AGENDA – Engineering and Construction Committee

- III. Report of Status of Operations and Construction
- IV. **Resolution R-66-25:** A Resolution Awarding a Contract for the Construction of the West Transmission Main along Book Road From 75th Street to the ComEd R.O.W. (Contract TW-6/25 Section 1 (Book Road))

DUPAGE WATER COMMISSION
WATERLINK EXTENSION
CONTRACT TW-6/25 SECTION 1 WEST TRANSMISSION MAIN

CATHODIC PROTECTION
DETAILS
SHEET 1 OF 3

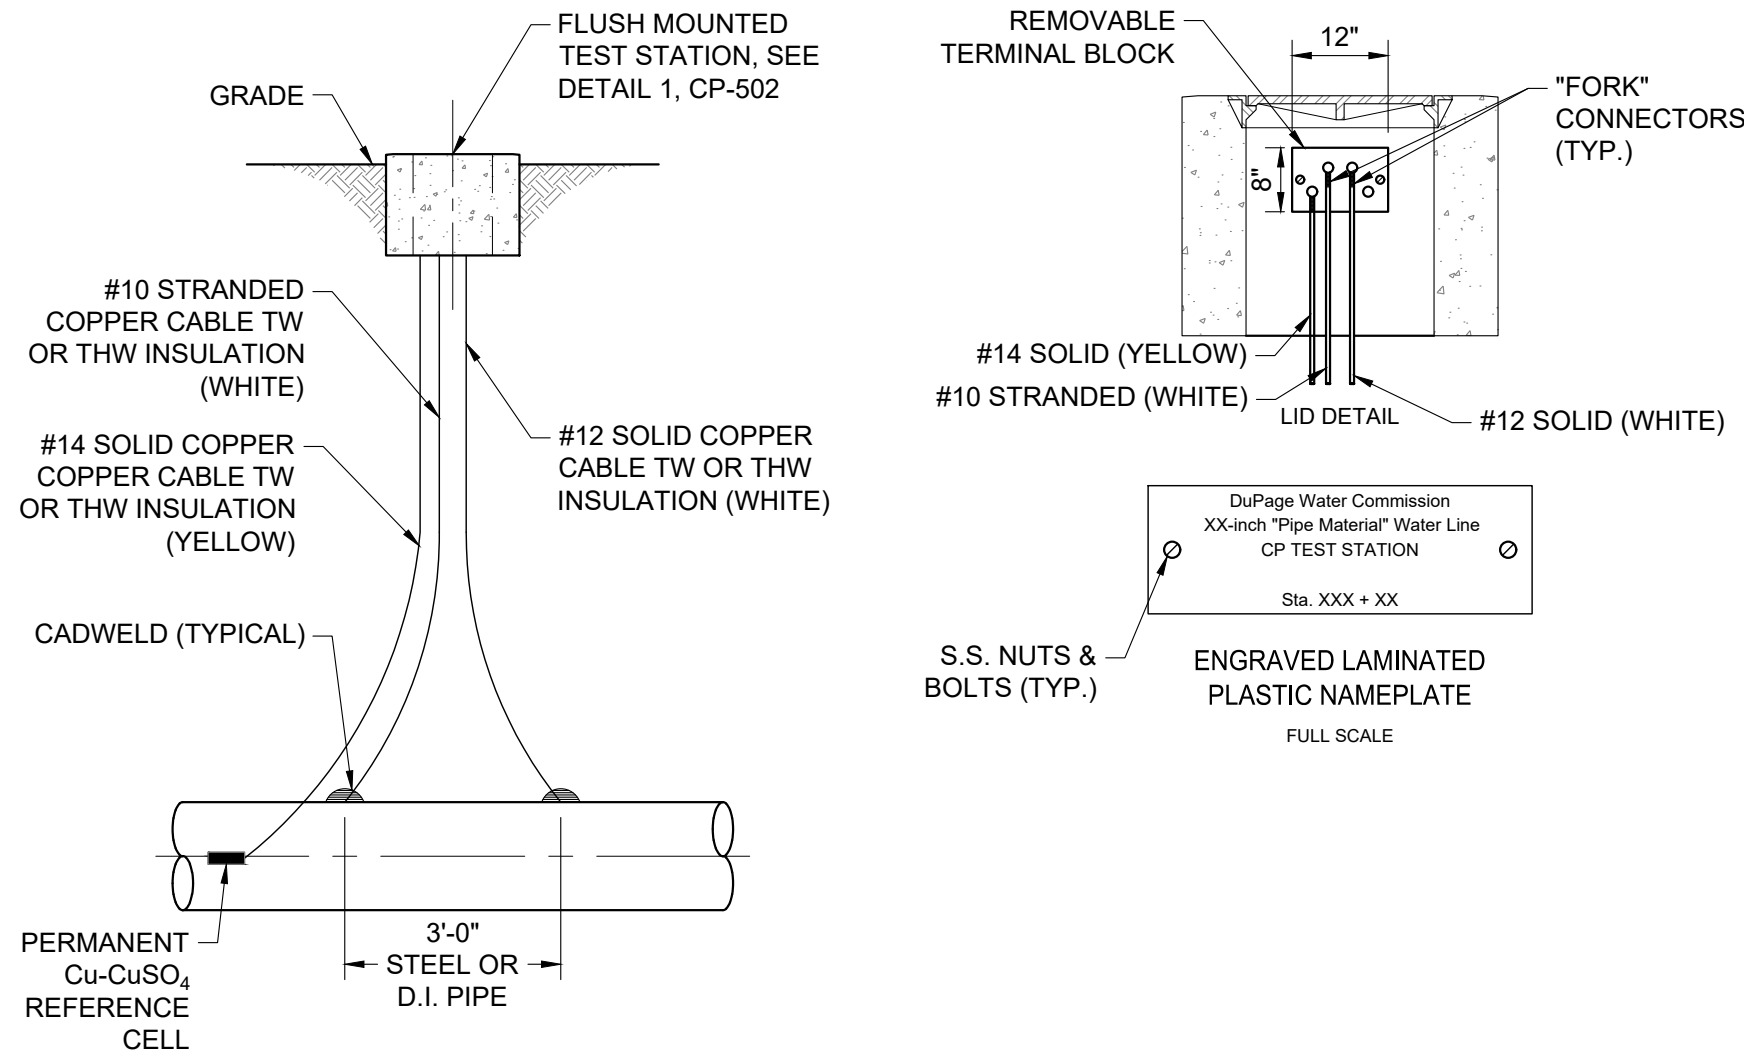
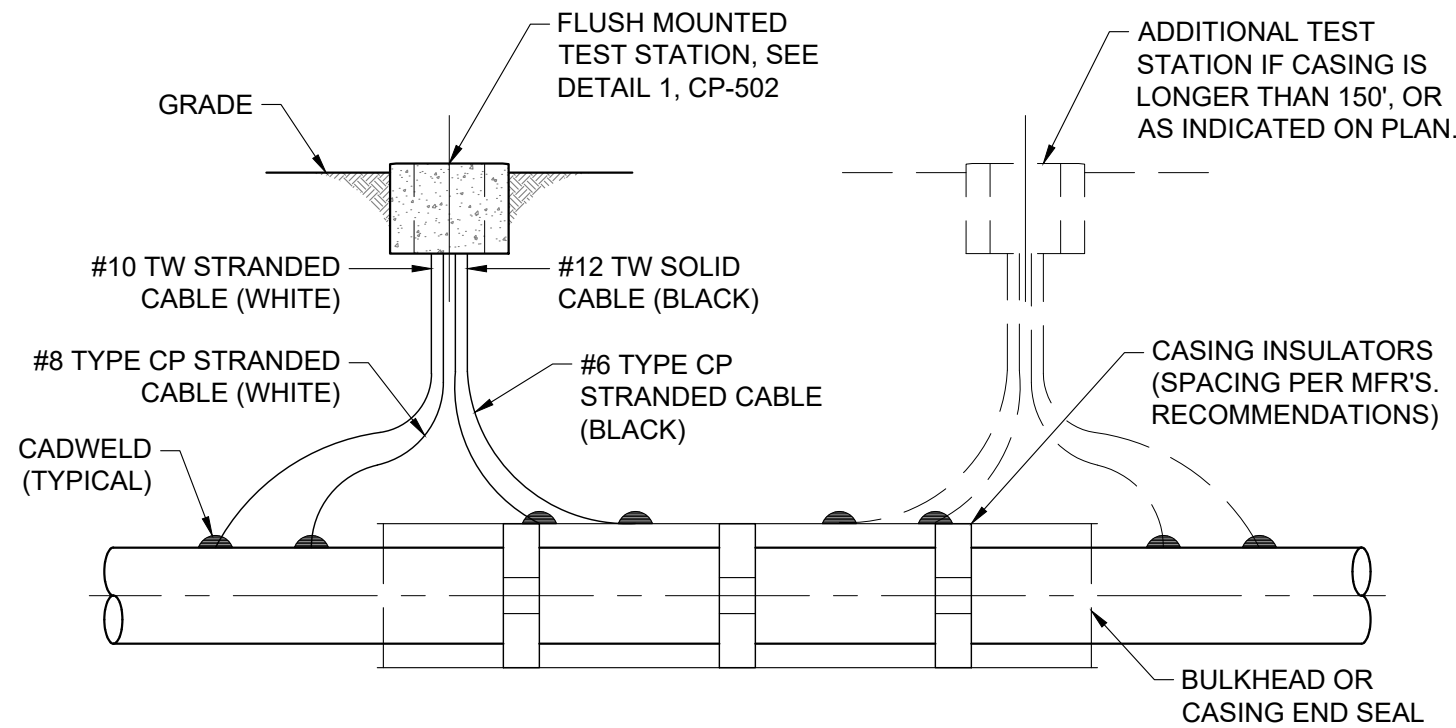
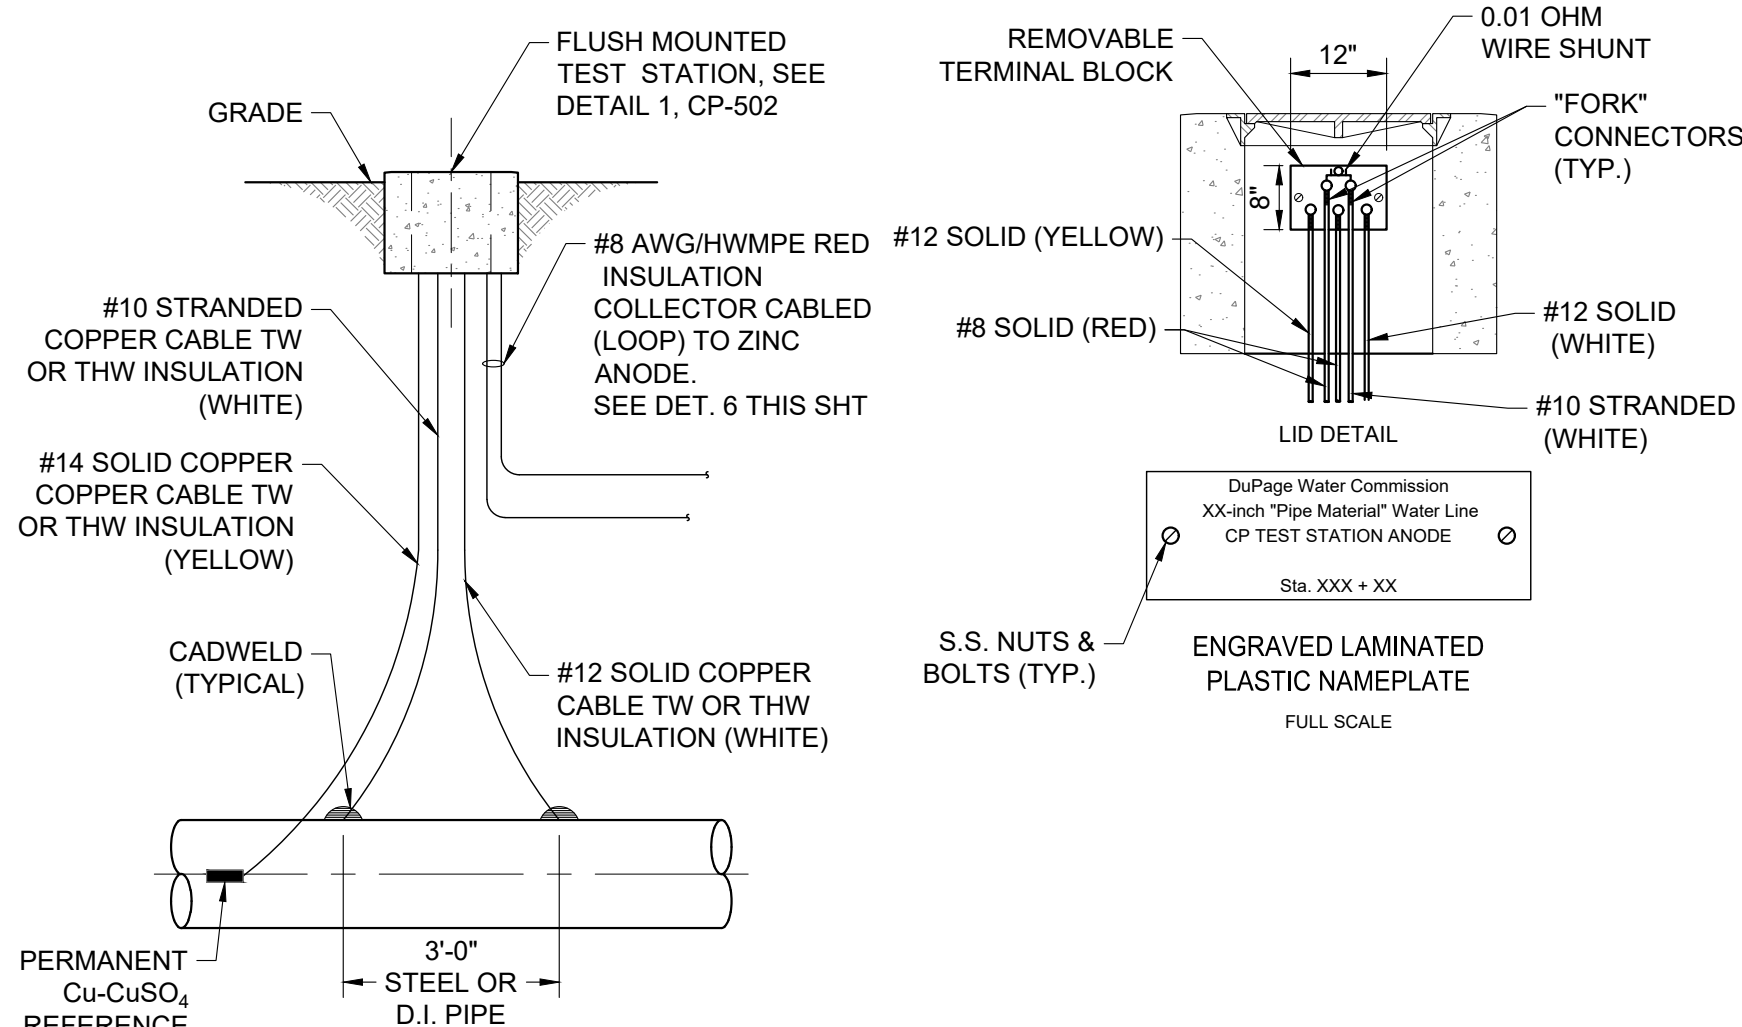
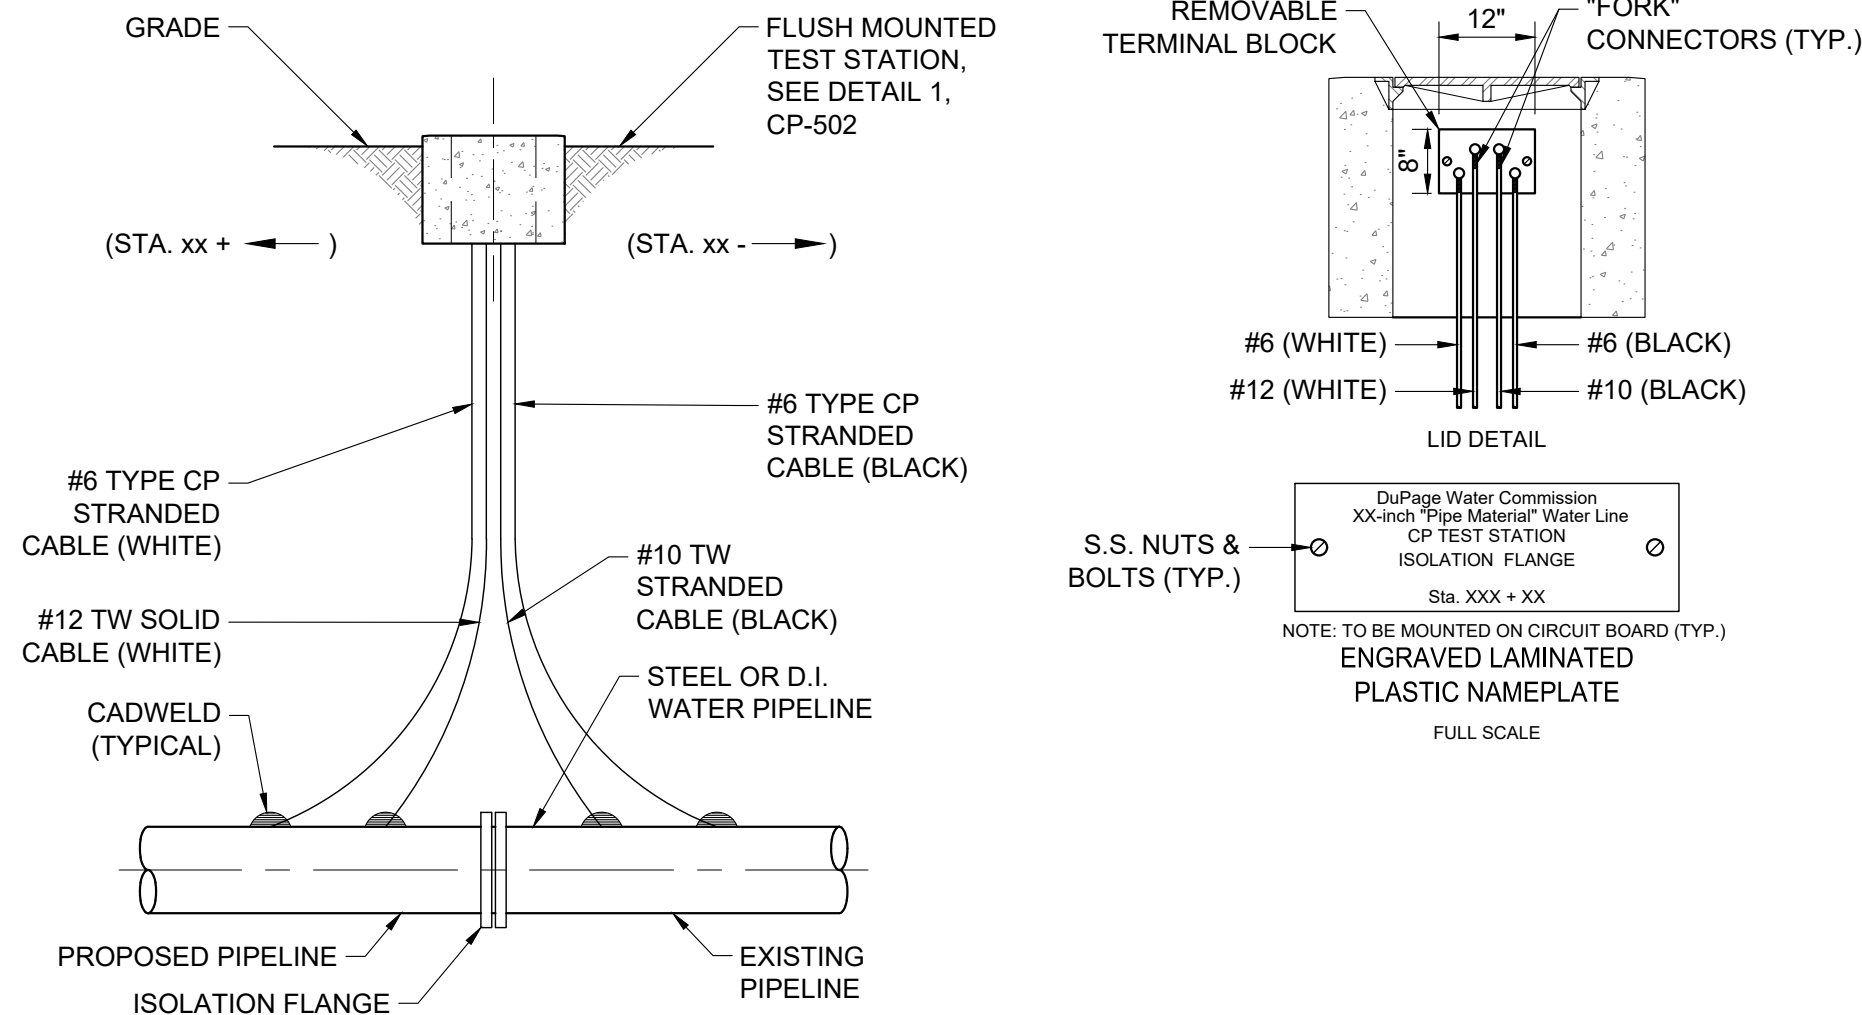
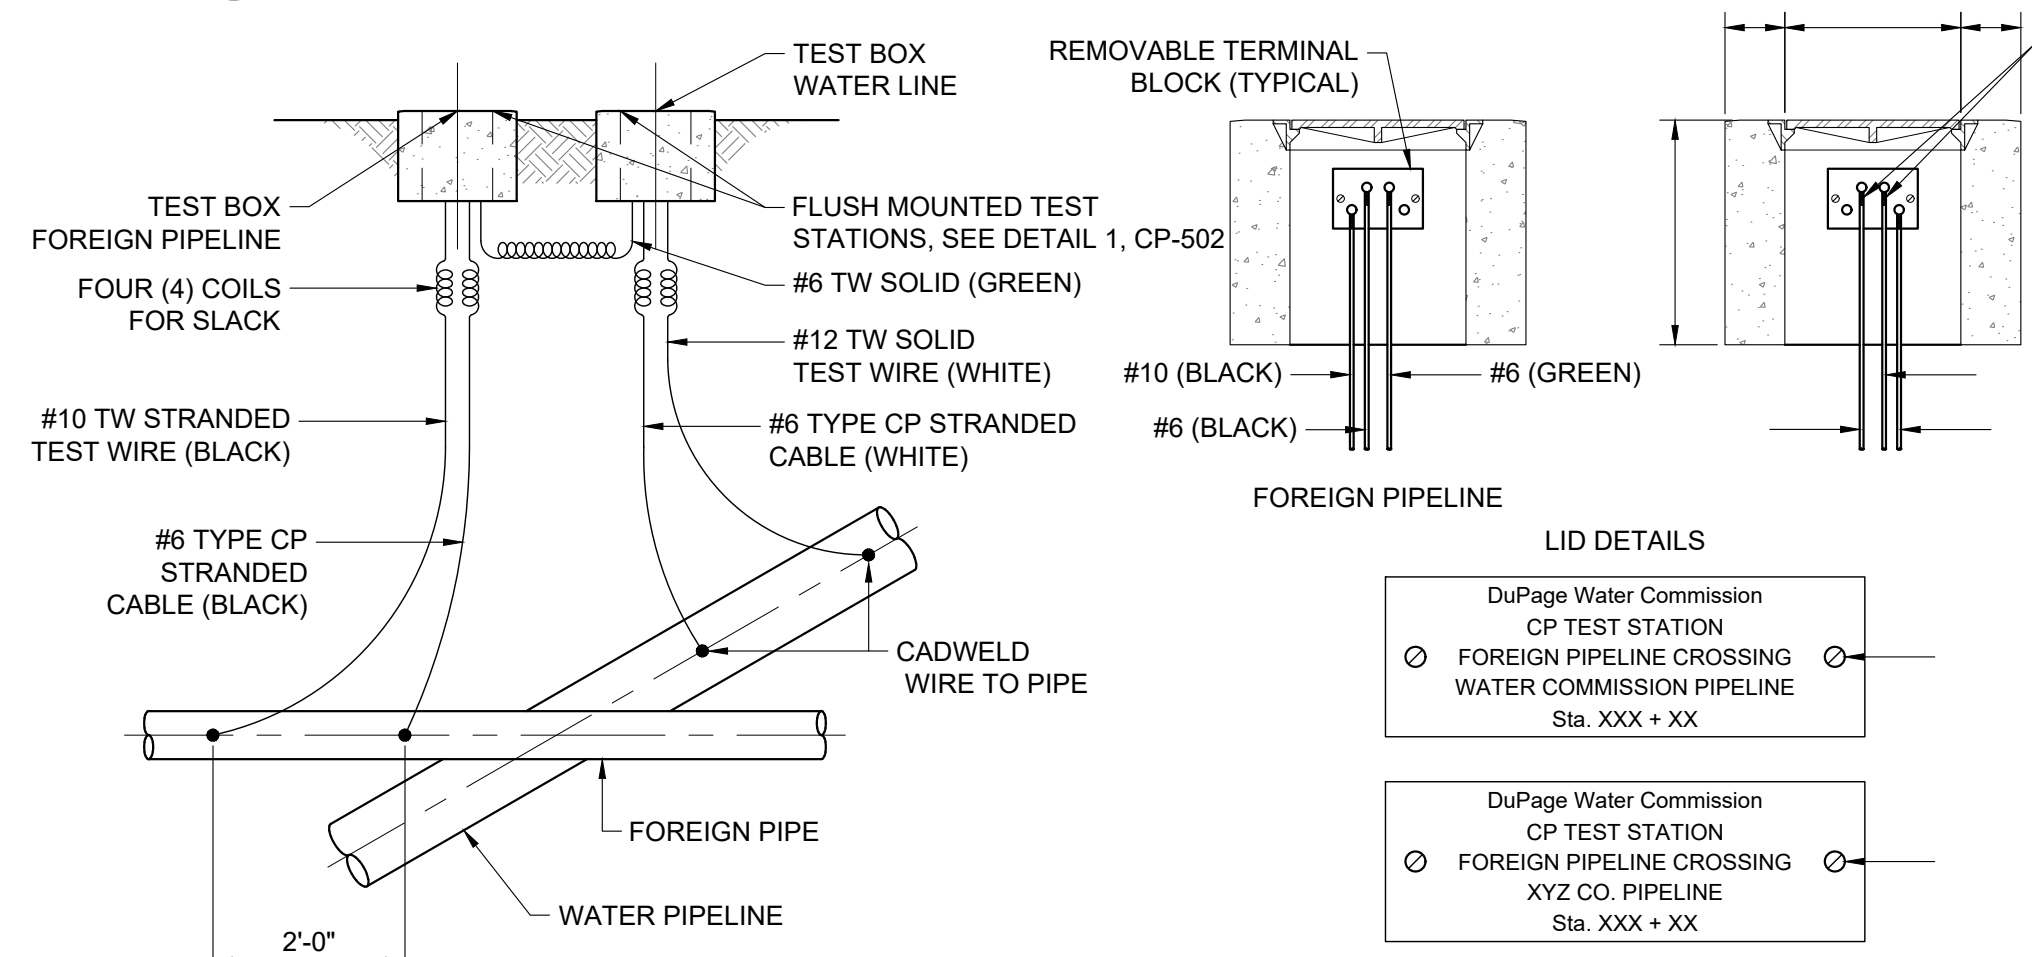
- V. Remove Sheet 183 of 199 (Drawing CP-501) in its entirety and replace with the attached revised Sheet 183 of 199.
- W. Remove Sheet 184 of 199 (Drawing CP-502) in its entirety and replace with the attached revised Sheet 184 of 199.
- X. Remove Sheet 185 of 199 (Drawing CP-503) in its entirety and replace with the attached revised Sheet 185 of 199.
